Item Name: Crosstube Turning Detail

DRAWING NO. D212-664-141	TITLE XTUBE ASSY (205/212/412 HI FWD)	REV. D	DART AEROSPACE LTD ENGINEERING ORDER		D.E.O. NO. D212-664-141-D-1	SHEET NO. SHEET 1 OF 2	SCALE NTS
DRAWN	CHECKED	MP	MFG. APPR.	BE	APPROVED	MP	DE APPR.
DATE 11.04.07	DATE 11.07.11		DATE 11.04.12		DATE 11/04/12		DATE 11.04.12

DRAWING NO. D212-664-141	TITLE CROSSTUBE ASS'Y (205 HI FWD)	REV. D	DART AEROSPACE LTD ENGINEERING ORDER		D.E.O. NO. D212-664-141-D-2	SHEET NO. SHEET 1 OF 1	SCALE NTS
DRAWN <i>IP</i>	CHECKED <i>AS</i>	MFG. APPR. <i>AS</i>	APPROVED <i>MD</i>		DE APPR. <i>MD</i>		
DATE 11.07.15	DATE 11.07.20	DATE 11.07.21	DATE 11/07/21		DATE 11.07.21

DART AEROSPACE LTD		Work Order:	77750
Description: Crosstube Assembly (205/212/412 High Fwd)		Part Number:	D212-664-141
Inspection Dwg: D212-664-141 Rev: D		Page 1 of 1

D212-664-141/-141B
ASSEMBLY DETAIL

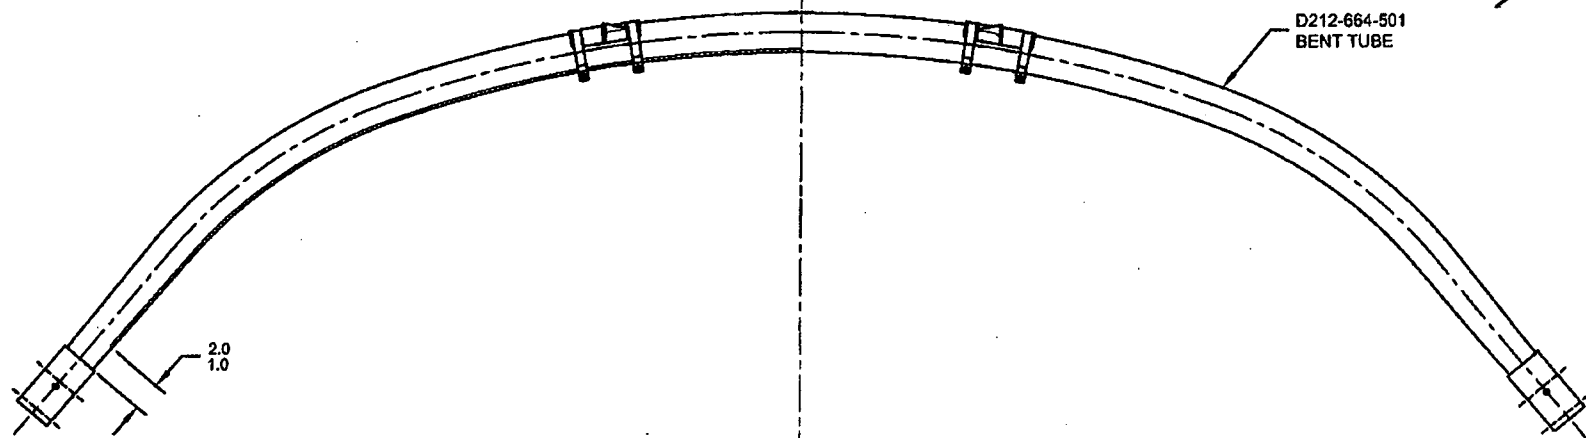
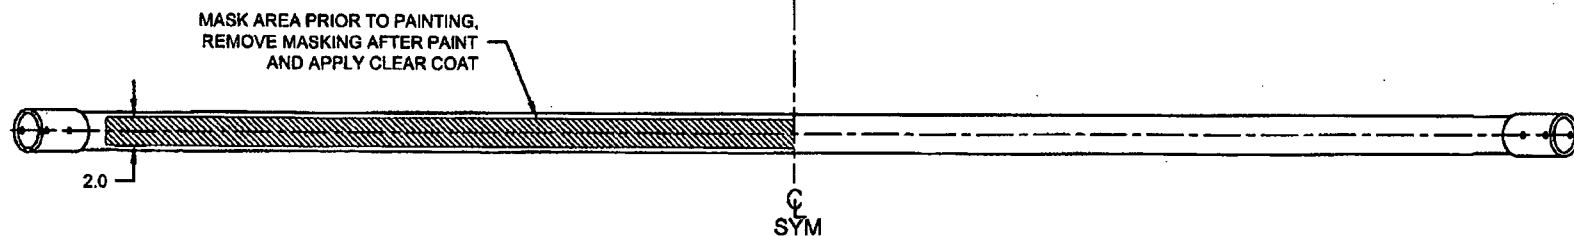
PURPOSE:

ADD AN INSPECTION WINDOW TO UNDERSIDE OF CROSSTUBE.

CHANGE:

NOTES 2 OF SHEET 1 IS AMENDED AS FOLLOWS:

- 2) FINISH: CHEMICAL CONVERSION COAT PER DART QSI 005 4.1
PRIME INSIDE AND OUTSIDE PER DART QSI 005 4.2
MASK UNDERSIDE OF CROSSTUBE AS SHOWN (HATCHED AREA) AND
PAINT OUTSIDE PER DART QSI 005 4.2
REMOVE MASKING AND APPLY CLEAR COAT
